# Exhibit 45

**R14-24**  
**Sanitary District of Decatur**  
**April 16, 2018 Response to IEPA and USEPA**  
**Comments Dated January 16 and 19, 2018**

Exhibit 45  
Sanitary District of Decatur (R14-24)  
Response to IEPA/US EPA Comments

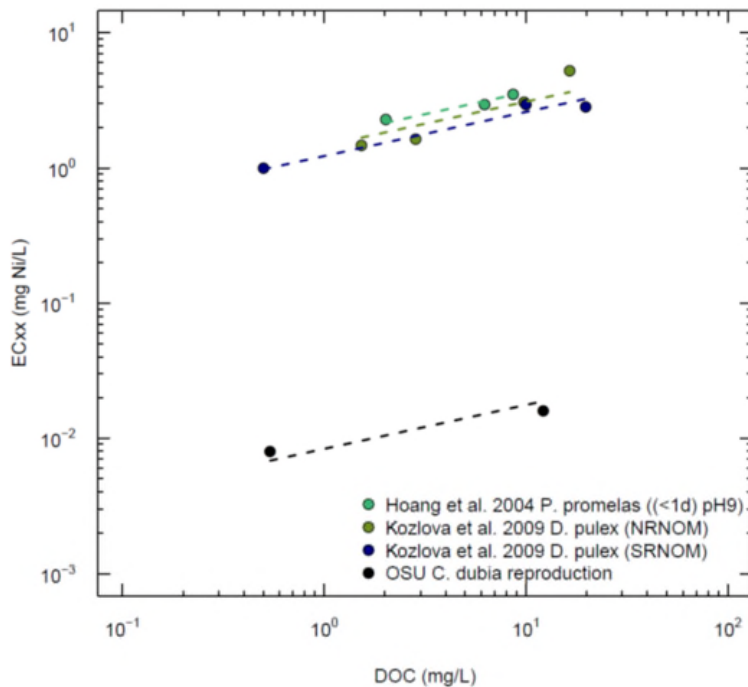
However, there is a good DOC relationship evident in the Hoang study, and we can test to see whether that relationship is similar to that seen in the OSU and Kozlova data. Most of the Hoang data we included in our review are from the Hoang et al 2004 paper. In some of the figures we have presented previously, we also incorporated additional unpublished Hoang data that were supplied to us as a personal communication from Tham Hoang. For the purpose of the ANCOVA, it is appropriate to consider only those data that were included in the 2004 paper, since they were based on tests that were conducted at the same time on the same population of test organisms. If those data are included in the analysis, the ANCOVA produces virtually the exact same result as if we include only the OSU and Kozlova data (with a pooled slope of 0.325). The ANCOVA results indicate that the individual slopes from all three studies are not different. Therefore, we can conclude that the DOC response in each of these three tests are not different from each other.

- Expanded discussion on why multiple species are relevant, and why Kozlova and Hoang data are relevant
- Added FHM to the ANCOVA results
- Added a new discussion of uncertainty in the OSU slope
- Conducted a Monte Carlo analysis to quantify confidence intervals around the DOC slope
- Expanded the discussion to show that the ANCOVA derived slope is consistent with the response seen in the OSU data and is within the confidence interval on the slope of the response in the OSU data.

**Commented [R25]:** Figure is now included in the WER report as Figure 2.

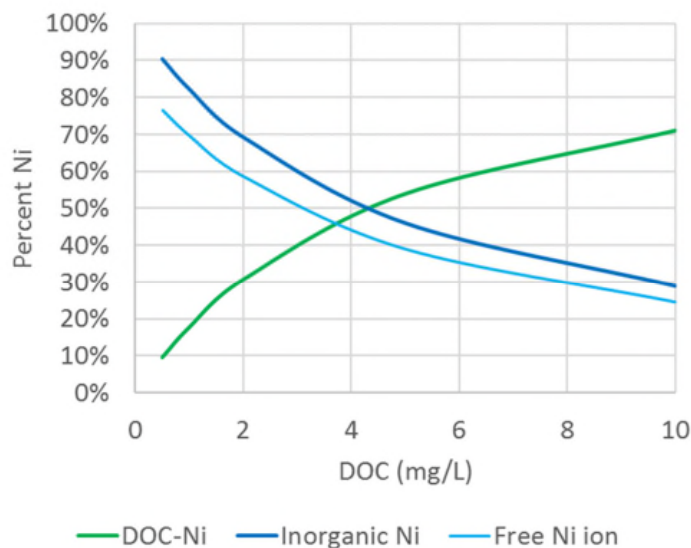
Additionally, as already noted, one thing that might be done to provide support from a BLM perspective is to report the expected shift in speciation due to the DOC in the different test waters, using the speciation models in the BLM. After all, the BLM is premised on free nickel activity driving response, so the BLM predictions would simply reflect such speciation changes, and providing these changes would be more simple, direct, and convincing.

**Commented [JA23]:** EPA's understanding is that SDD will add the figure below to its petition and/or supporting documentation along with a description of the input parameters and total Ni concentration used to generate the figure. The input parameters and total Ni concentration used in the BLM should correspond with those for SDD's effluent and downstream water in the Sangamon River. SDD will also add text describing how this figure supports the proposed WER.

We could include a figure and discussion to further reinforce the primary message in the BLM report that points to DOC as among the most important toxicity modifying factors for nickel in the Sangamon River. For example, in the figure below the distribution of nickel between organic and inorganic forms is shown over a range of DOC concentrations. At low DOC most of the dissolved nickel will be in the form of inorganic complexes shown as a dark blue line (for example, Ni-sulfate, Ni-bicarbonate, and Ni-hydroxide). As the DOC concentration increases, the amount of nickel in organic complexes increases (green line) with a corresponding decrease in inorganic complexes. The amount of the free nickel ion (light blue line) also decreases with increasing DOC. Since nickel bioavailability is more closely related to free nickel, the BLM predicts that increasing DOC concentrations will reduce nickel bioavailability. This result indicates that natural waters with a lot of natural organic matter (e.g., high DOC) will have reduced nickel bioavailability. The elevated DOC concentrations in the Sangamon River, therefore, are expected to reduce nickel toxicity. Hence, information about nickel speciation supports the derivation of a site-specific criterion for nickel in the Sangamon River.

**Commented [RCS24R23]:** We will include this figure and associated discussion.
